## **Attachment 2**

### **Revisions to Select Figures for Letter LTR-NRC-13-6 to Fulfill Conditions 6 and 7 of the SER for WCAP-12610-P-A & CENPD-404-P-A Addendum 1-A (Non-Proprietary)**

**February 2015**

**Figure 7 - Measured Fast Flux for Test Assembly A1 - 1 Cycle Irradiation**

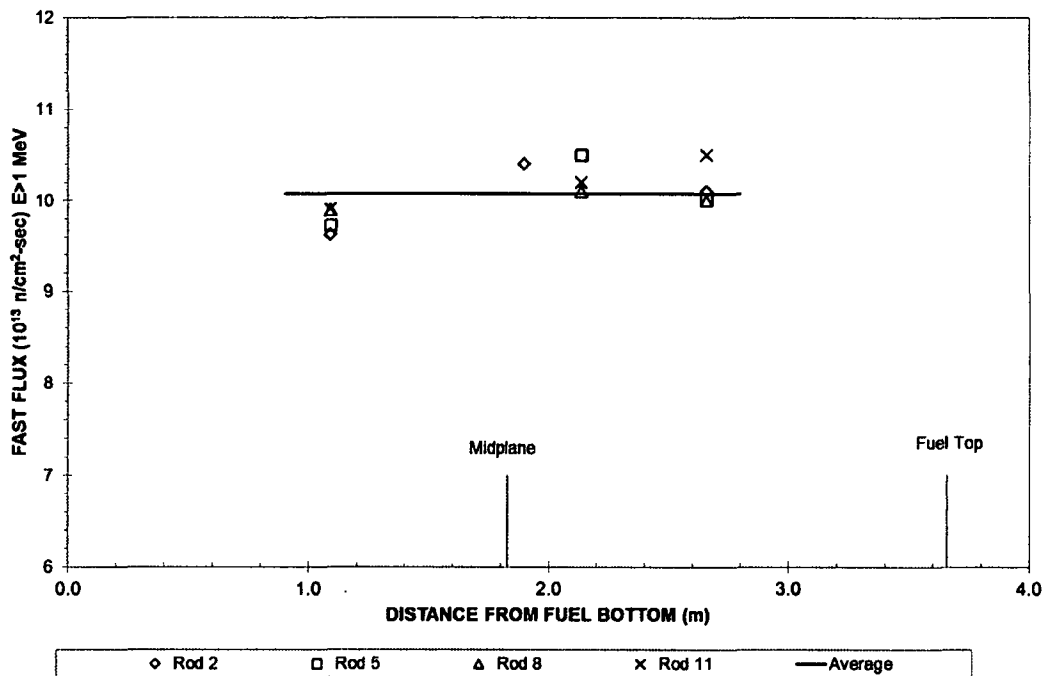
The measured fast flux data for assemblies A1, A5, A3 and A2 were revised using an improved analysis method. In addition, there were very small corrections in the stress analyses for the Vogtle creep/growth data that have been made. These updates have resulted in minor changes in the figures in LTR-NRC-13-6, Section 3: Condition 7 Compliance- Creep/Growth Data, and in Figure 23 in Section 4: comparison of profilometry data with predictions. These minor changes in figures do not change the conclusions and discussions. Therefore, only the updated figures and the corrected measured fast flux values are updated below. The rest of LTR-NRC-13-6 remains unchanged.
